CENTENNIAL AIRPORT
ARAPAHOE COUNTY PUBLIC AIRPORT AUTHORITY

June 5, 2019

Reference: Denver Metroplex Draft Environmental Assessment

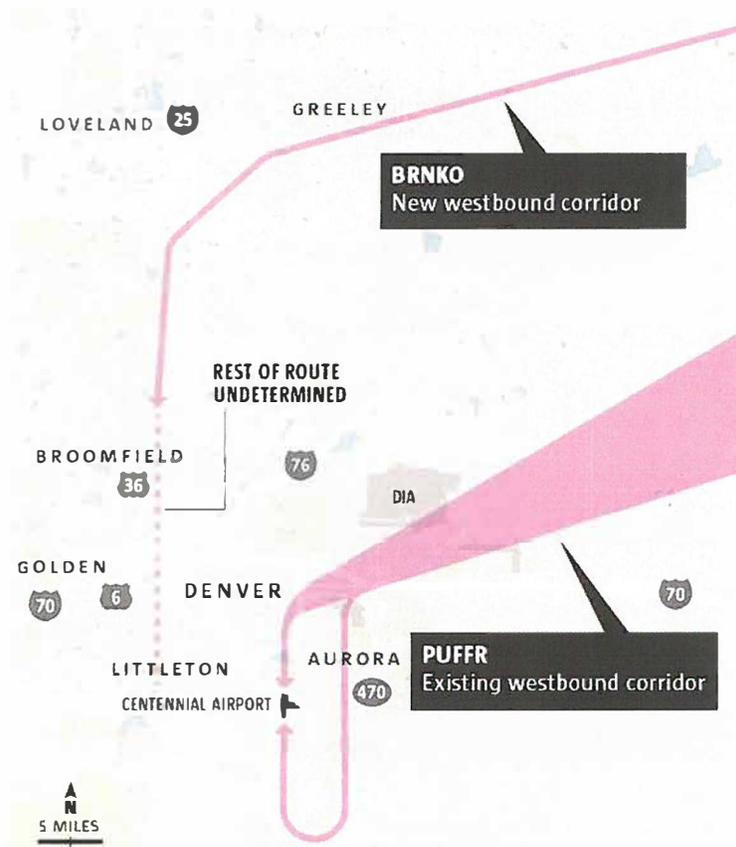
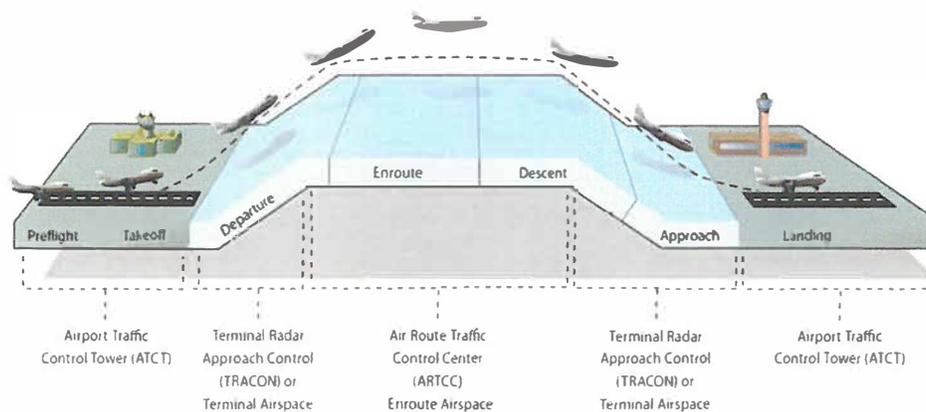
SAFETY, NOISE AND OVERFLIGHT CONCERNS. The FAA proposes to eliminate a “little-used” (FAA’s term) arrival procedure called PUFFR and replace it with the so-called BRNKO arrival procedure. The PUFFR arrival procedure currently takes aircraft coming in from the north and east over and above Denver International Airport.

The proposed BRNKO arrival procedure takes airplanes destined for Centennial Airport some 50 miles further north towards Ft. Collins-Loveland, before aircraft are vectored eastward along the foothills of the Rocky Mountains where downdrafts, wind shear and volatile wind conditions make it both uncomfortable due to turbulence, as well as dangerous due to unpredictable downdrafts coming from the mountains. When weather or winds are not a factor, the corridor is popular with small aircraft flying in both directions creating safety concerns as aircraft with vastly different speeds will operate in the same airspace at nearly

identical altitudes. While safety is typically the purview of the FAA, numerous pilots, who are the ultimate arbiters on safety, have to fly this route including PINRR (for aircraft arriving from the west) and have advised the FAA that the proposed BRNKO and PINRR arrival procedures are potentially dangerous in addition to the discomfort for their passengers.¹⁵ Numerous pilots have indicated that they will simply not use the BRNKO/PINRR and look to use the DUNNN arrival procedure instead. Therefore, from the book of unintended consequences, the FAA should consider alternative arrival procedures or take no action on PUFFR. The FAA also claims that only very few aircraft use the PUFFR, which begs the question, why change?

While the FAA has touted the reductions in fuel burn and emissions as part of Metroplex, it did not include an analysis in the D/EA pertaining to the increases in fuel burn and emissions generated by aircraft using the BRNKO rather than PUFFR procedure. The FAA should be required to provide this data, including associated costs.

In closing, we urge the FAA to complete the studies mandated by Congress; address any changes in an Environmental Impact Study including cumulative impacts over 20 years; and, eliminate the BRNKO and PINNR procedures in favor of more acceptable alternatives including taking no action on PUFFR.
